Access Compliance Report

Public Rights-of-Way

(Curb Ramps)

Intersection ID: 28449	Main Street: LAURENFIELD_DR	Cross Street: SUMMER_CREEK_LN	Location: SW
ADA ID: C9B6AC126745	Ramp Type: BlendTrans1	Initial Pass/Fail: Fail	Overall Compliance: No
		Severity Score: 1.25

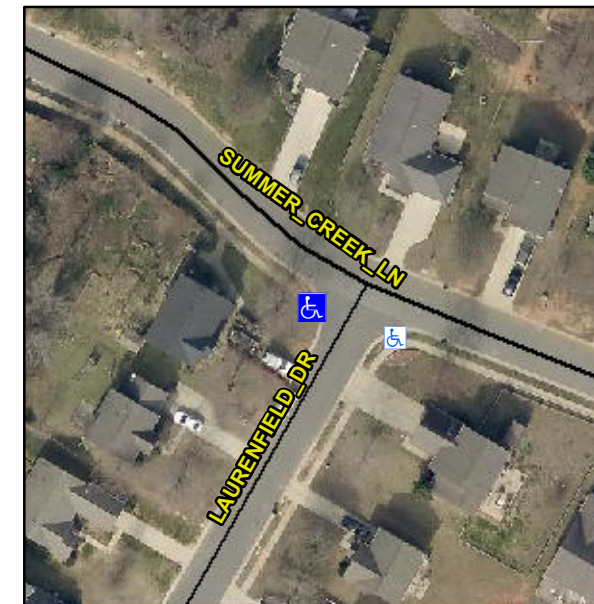
Not Found, R304.5.3

Compliance	Description	Data	Compliance	Description	Data
N/A	Ramp Length (in)	50.5	Yes	BlendTrans Slope (%)	3.9
Yes	Ramp Width (in)	76.0	No	BlendTrans XSlope (%)	2.3
N/A	Flare Type LT	N/A	N/A	Flare Type RT	N/A
N/A	Flare Slope LT (%)	N/A	N/A	Flare Slope RT (%)	N/A
N/A	Flare Traversable LT?	N/A	N/A	Flare Traversable RT?	N/A
N/A	Landing Length (in)	N/A	N/A	DWS Provided?	N/A
N/A	Landing Width (in)	N/A	N/A	DWS Contrast?	N/A
N/A	Landing Slope (%)	N/A	N/A	DWS Length (in)	N/A
N/A	Landing X Slope (%)	N/A	N/A	DWS Full Width?	N/A
N/A	Landing Curb? (Y/N)	N/A	N/A	DWS Offset (in)	N/A
N/A	Shared Landing?	N/A			
N/A	Gutter Ponding?	N/A	N/A	Gutter Slope (%)	N/A
N/A	Gutter Lip Ht (in)	N/A	N/A	Gutter X Slope (%)	N/A
N/A	Painted X Walk1?	No	N/A	Painted X Walk2?	N/A
	X Walk 1 Direction	To E		X Walk 2 Direction	N/A
	X Walk 1 Width (in)	N/A		X Walk 2 Width (in)	N/A
	X Walk 1 Slope (%)	8.3		X Walk 2 Slope (%)	N/A
	X Walk 1 X Slope (%)	4.2		X Walk 2 X Slope (%)	N/A

N/A	Ramp inside XWalk1?	N/A	N/A	Ramp inside XWalk2?	N/A
	Road Slope (%)	4.2		Clear Space?	N/A
	Road X Slope (%)	8.3	N/A	Clear Space to XWalk (in)	N/A
N/A	Any Obstructions?	N/A	N/A	Storm Grate/Utility Hazard?	N/A
	Obstruction Type			Storm Grate/Utility Type	
		N/A			N/A
			Yes	Surface Condition? (G/P)	Good
			No	Curb Slope (%)	11.7

Remove & Replace Curb Ramp With Two New Directional Ramps or Equivalent.
